# 1998 - 2002 Corvette: Service Bulletin: Audible Spark Knock (Detonation), MIL Illuminated, DTC P0332 Set

**Subject:** Audible Spark Knock (Detonation), MIL Illuminated, DTC P0332 Set  
(Replace Rear Bank Knock Sensor and RTV Area Around Sensor)

**Number:** 02-06-04-023

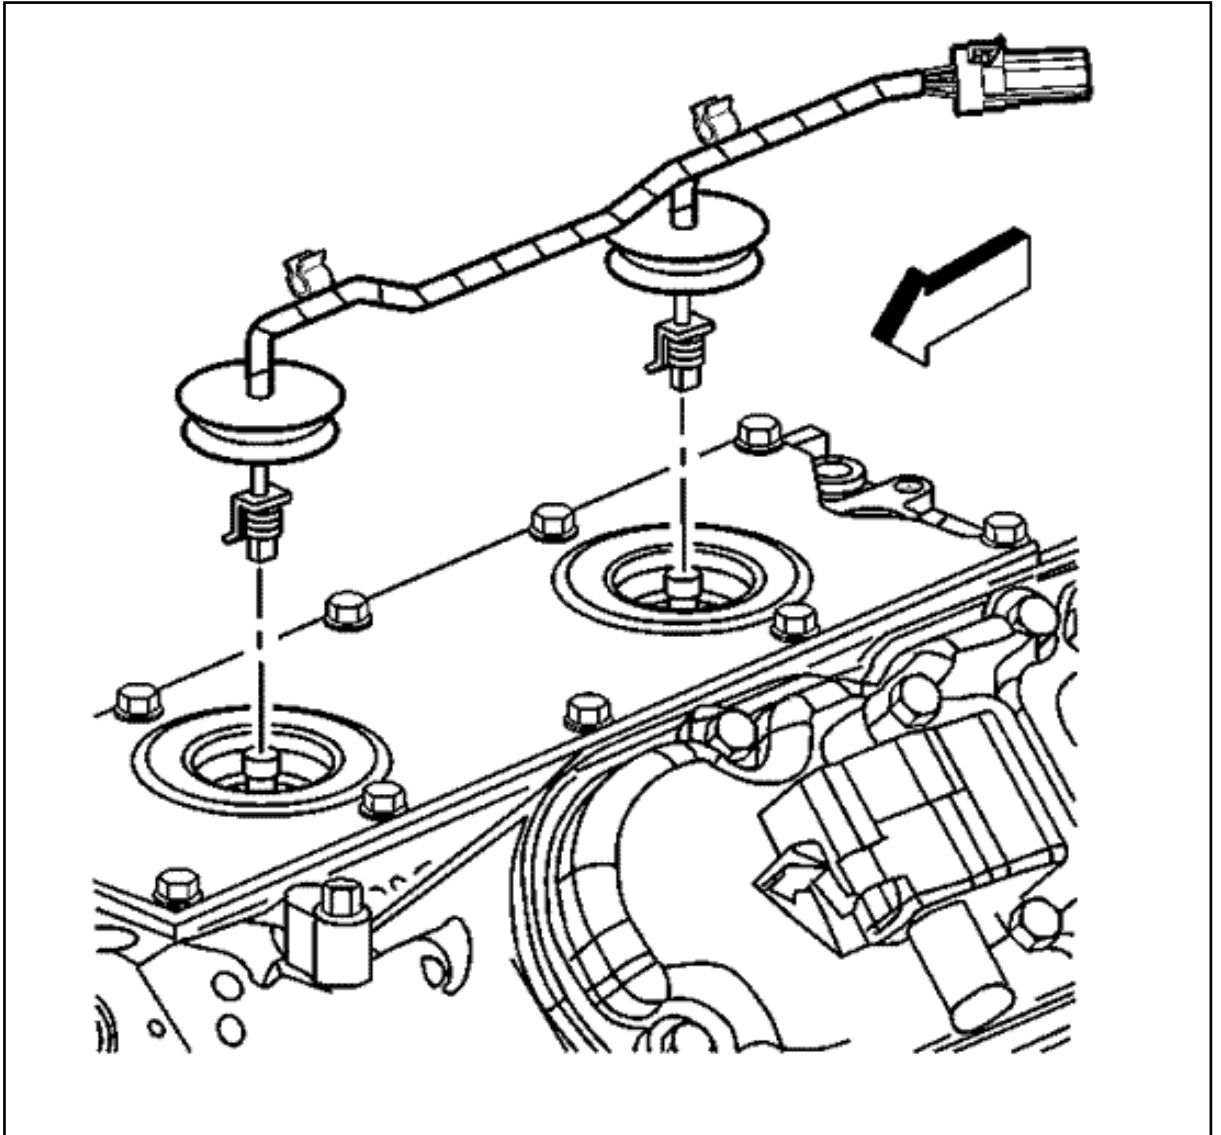
This condition may be the result of corrosion of the rear bank knock sensor due to water intrusion into the sensor cavity. This condition is more apparent on vehicles in which customers frequently wash the engine compartment.

Replace the rear bank knock sensor and build a dam (wall) around the sensor using RTV to divert water away from the sensor. Use the procedure and part number listed below.

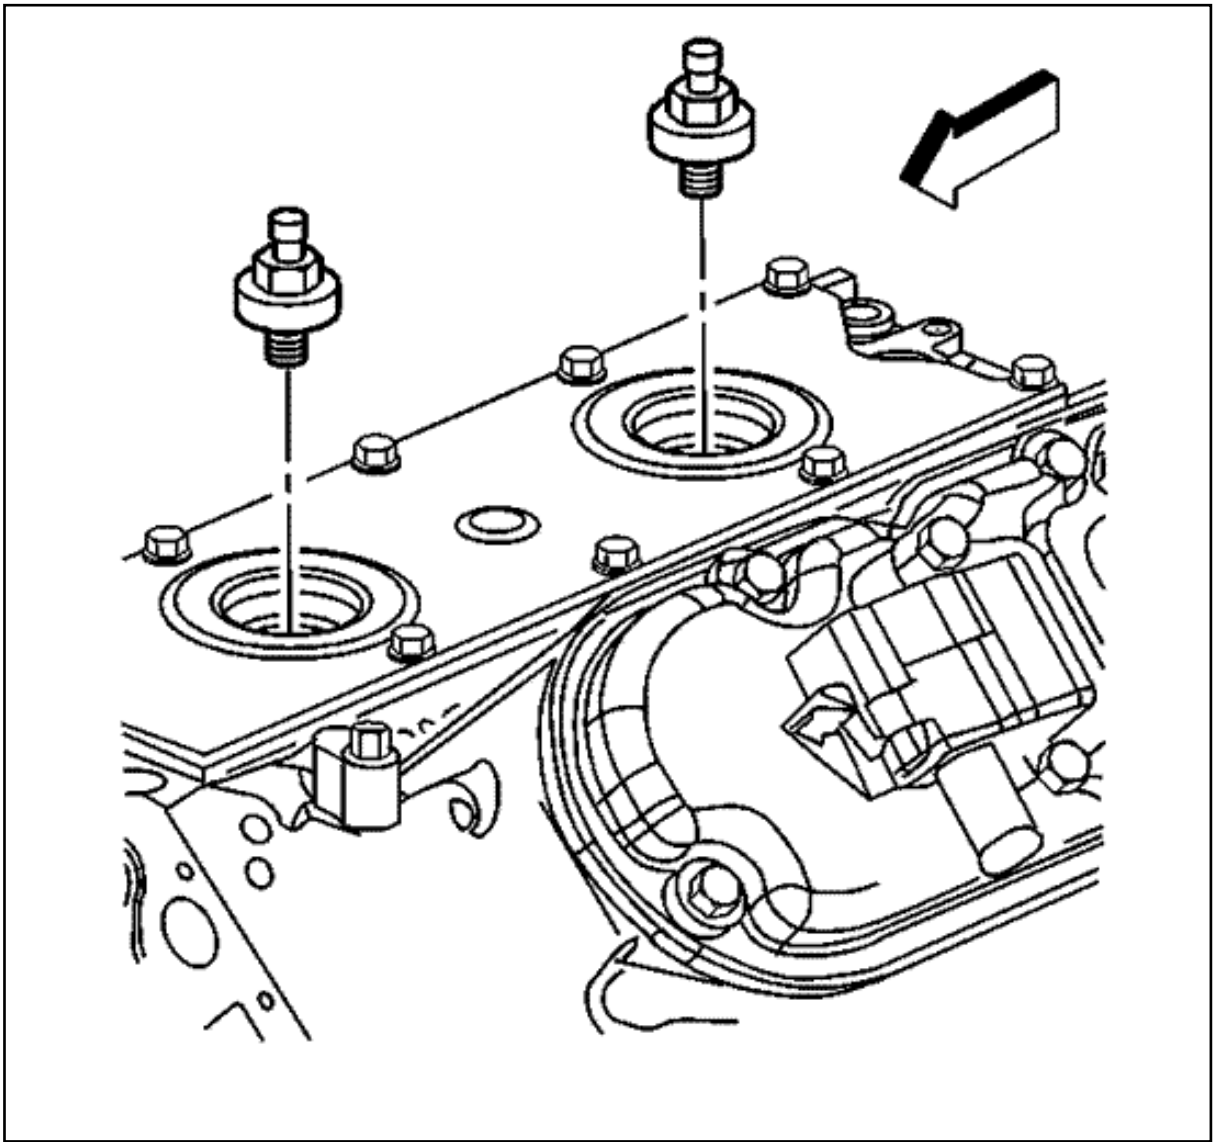
- Remove the wiring harness assembly from the knock sensor.

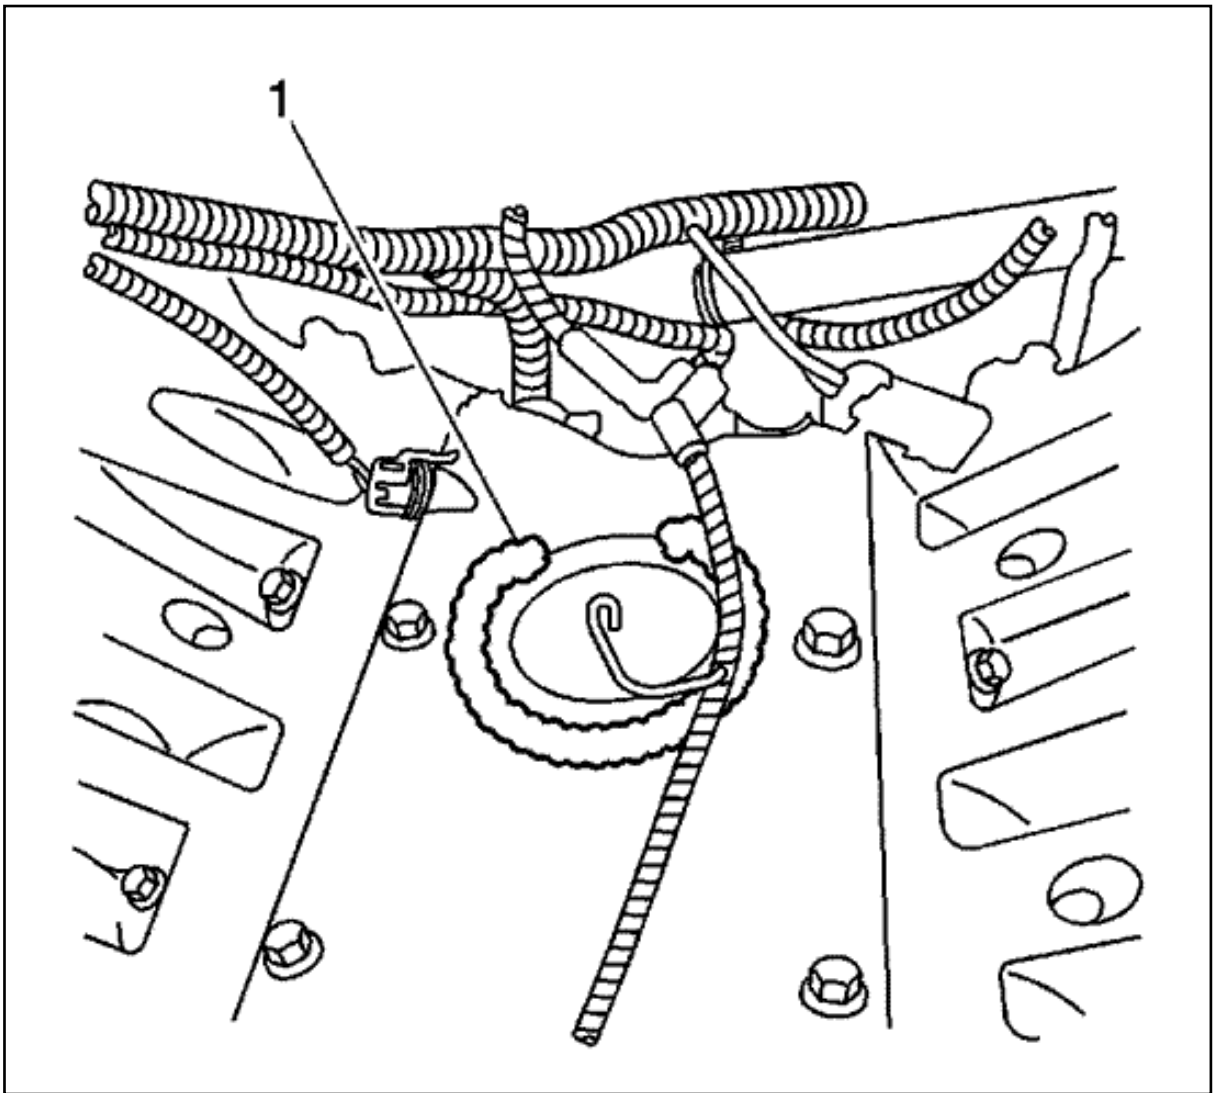
- Remove the rear bank knock sensor.
- Install the new rear bank knock sensor. **Tighten** the knock sensor to 20 N·m(15 lb ft).
- Install the wiring harness assembly to the knock sensor.

- Apply a bead of RTV silicone sealant approximately 9 mm (3/8 in) wide and 6 mm (1/4 in) high along the outside edge of the ridge on the engine block valley cover around the rear bank knock sensor. **DO NOT** form a complete circle. Leave the rear section open as shown.
- From the underside of the intake manifold, completely remove the
